ADDENDUM NO. 1

February 3, 2026

Perry Township Schools:
Southport High School Addition & Renovation Phase 1 (Activity Center Addition & Wrestling/Center Plant Renovation)
971 E. Banta Road
Indianapolis, IN 46227

TO: ALL BIDDERS OF RECORD

1 FLOOR PLAN - RAMP - UNIT Q

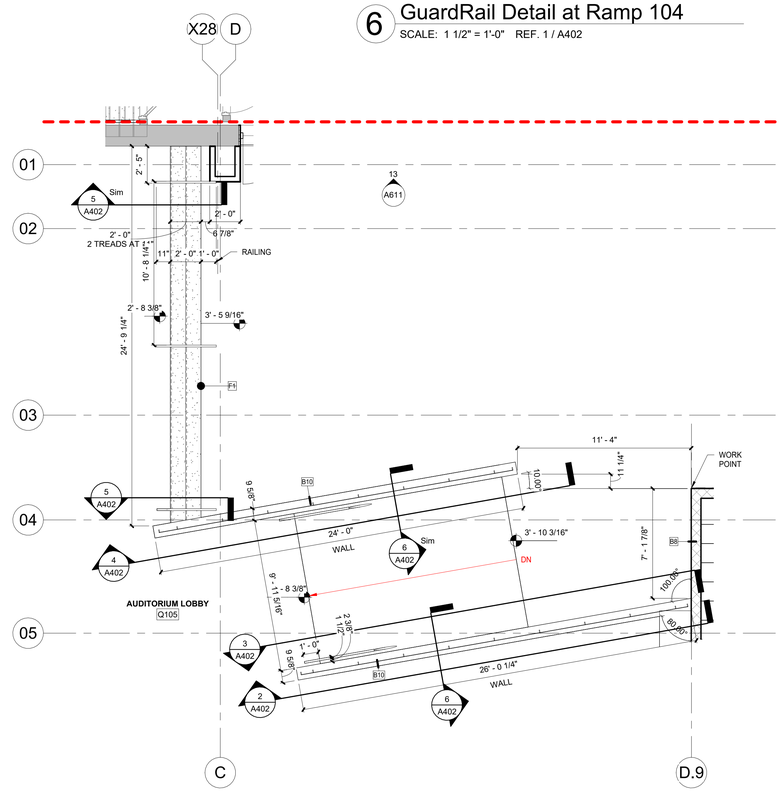
Change:
    - Add plan detail from sheet A402
    - Add Ramp Sections.
    - Add Railing details.

C-8.9

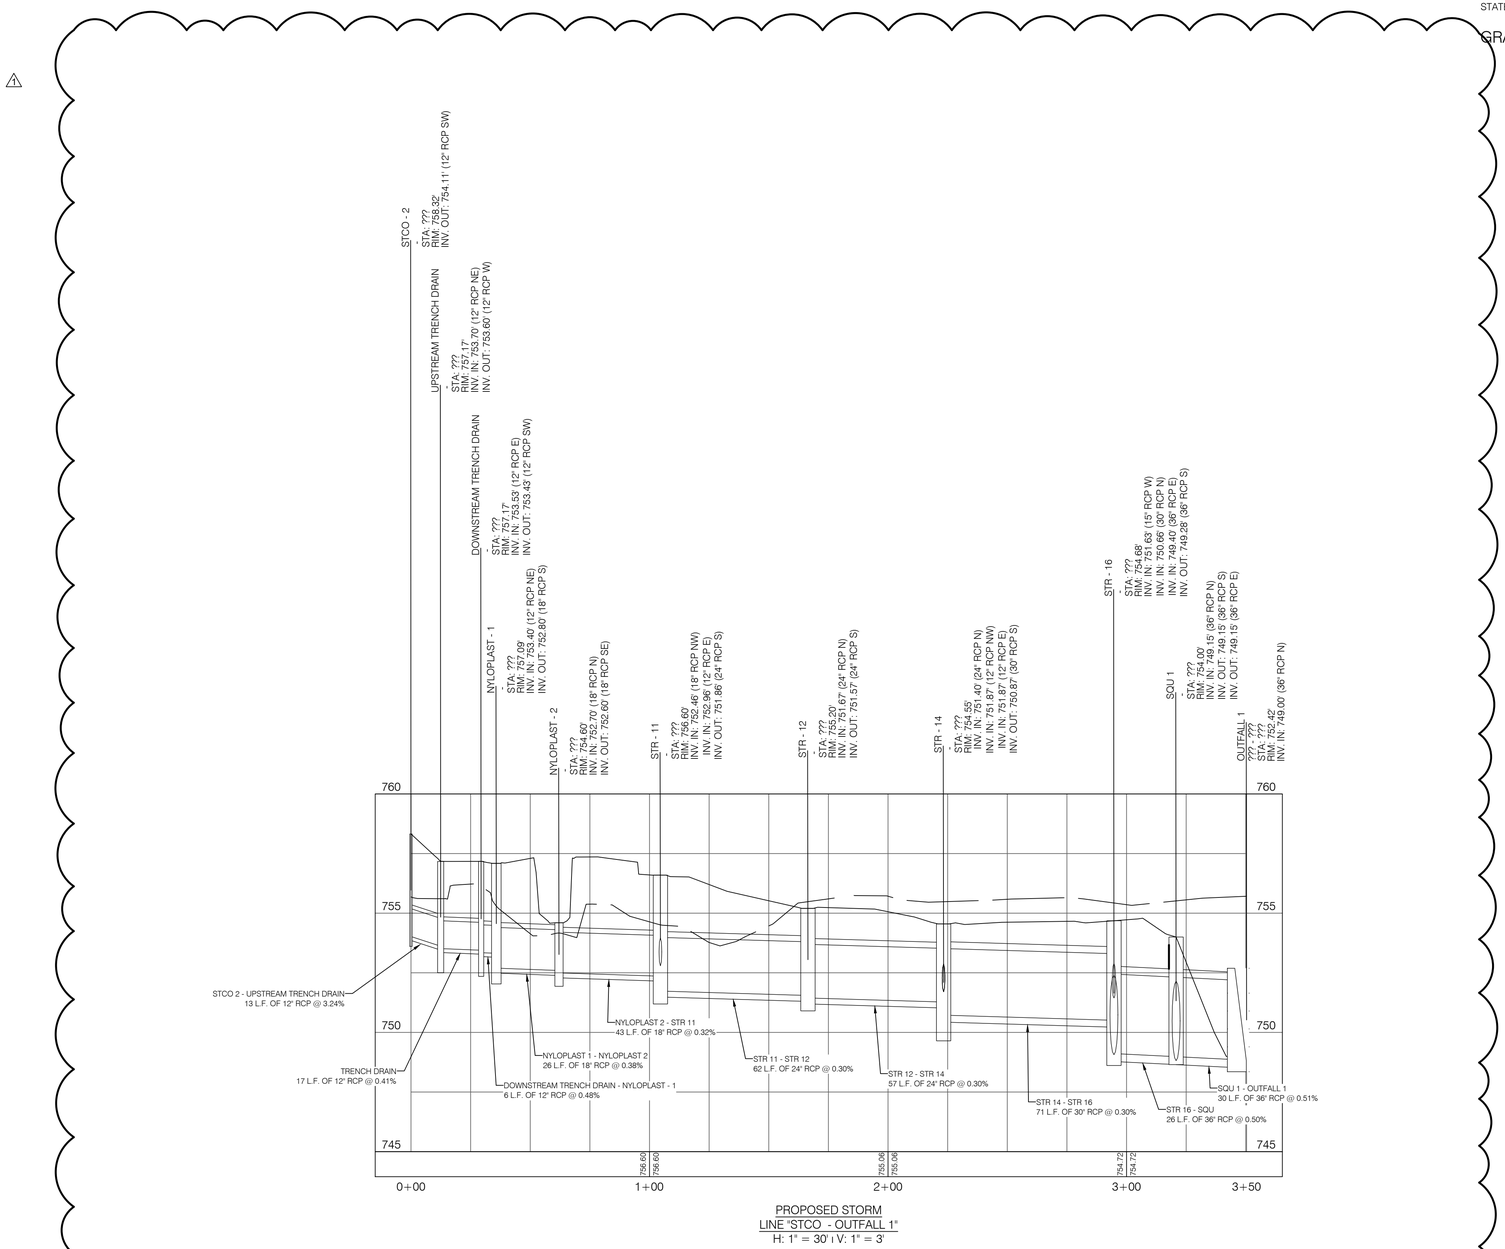
6. Drawing Sheet Number: C-8.10
   Drawing Sheet Title: Phase 1 Strom Profiles

Change:
   - Modify information on the profiles
     - Inverts
7. Drawing Sheet Number: C-8.16
   Drawing Sheet Title: Storm Details

C-9.4

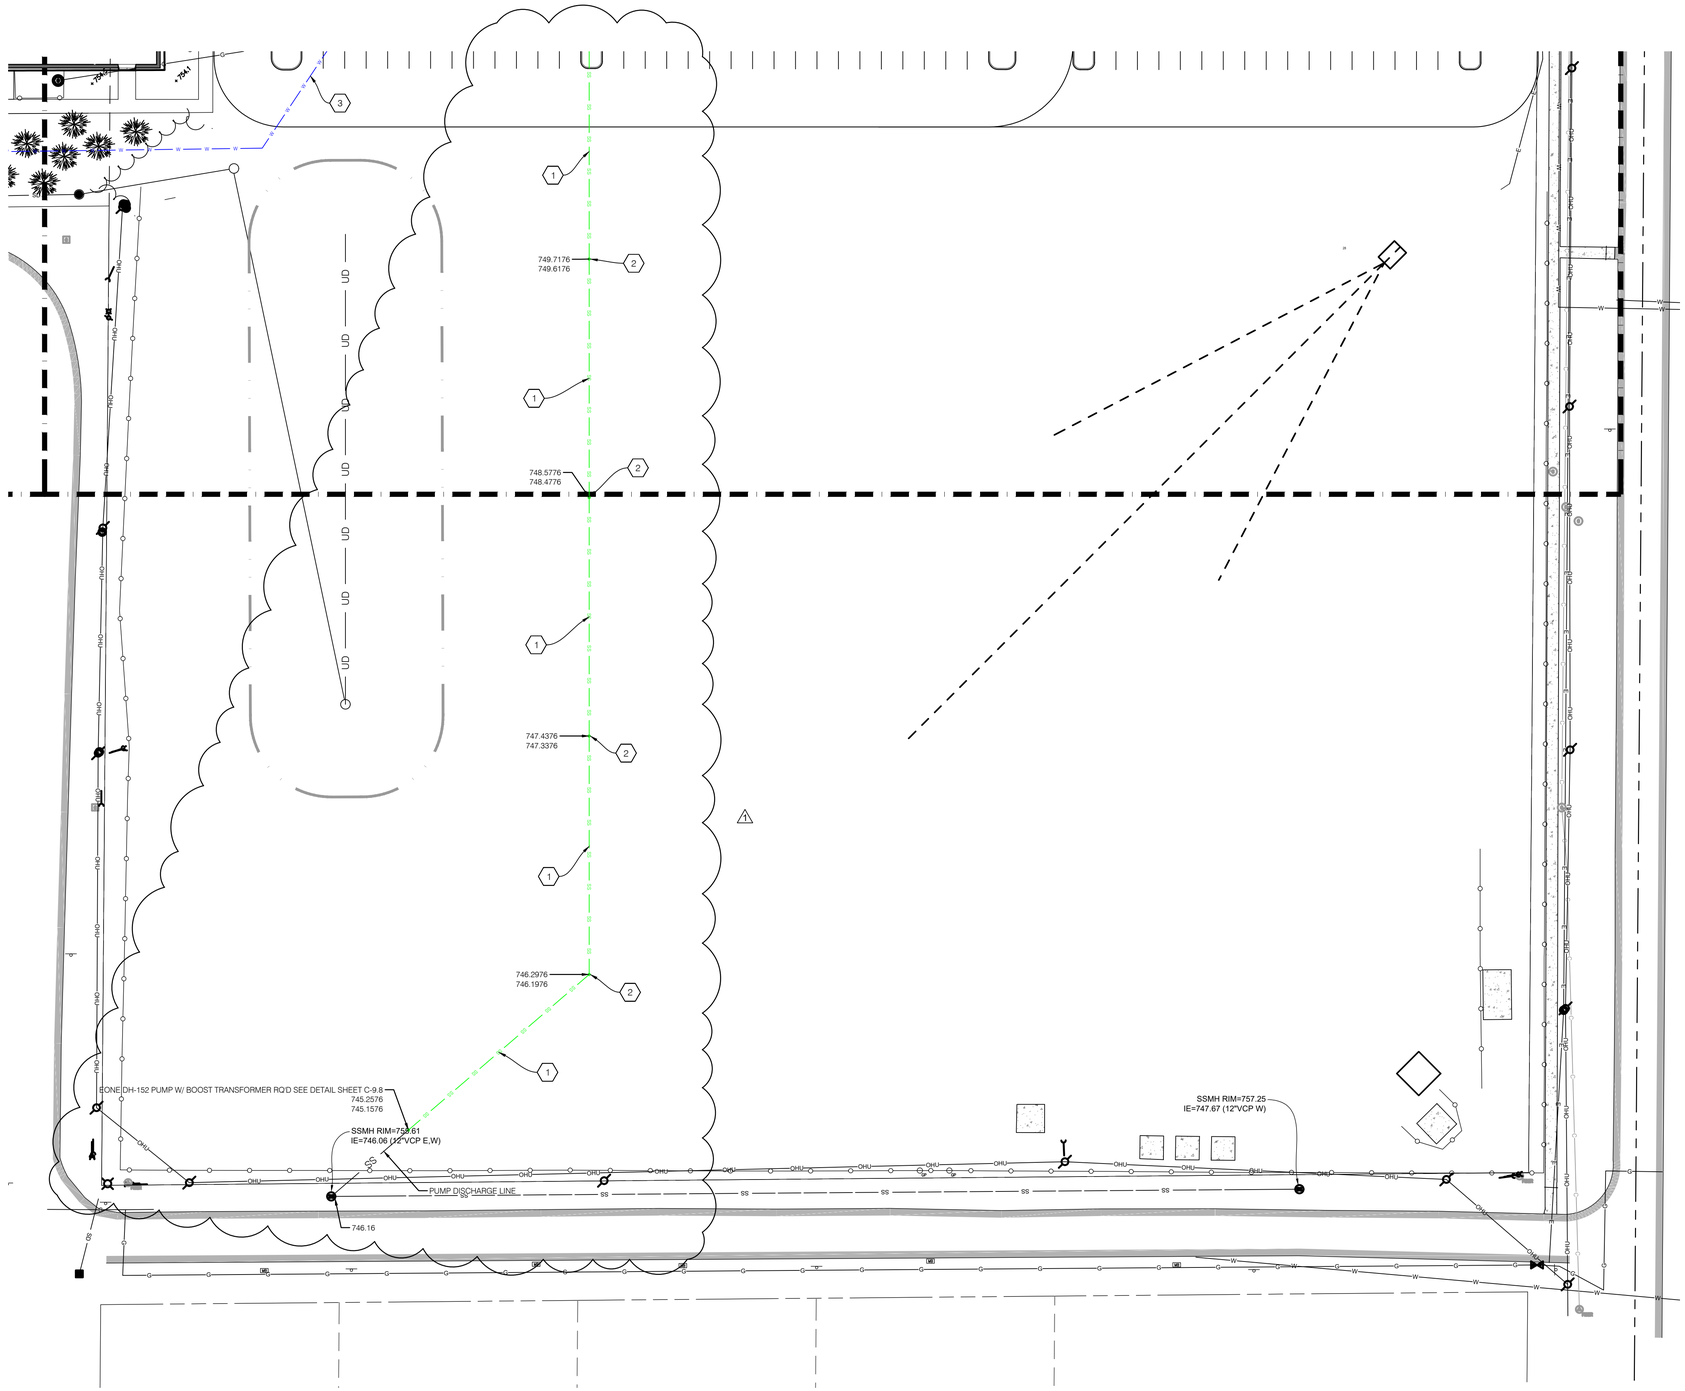
8. Drawing Sheet Number: C-9.4
   Drawing Sheet Title: Utility Plan
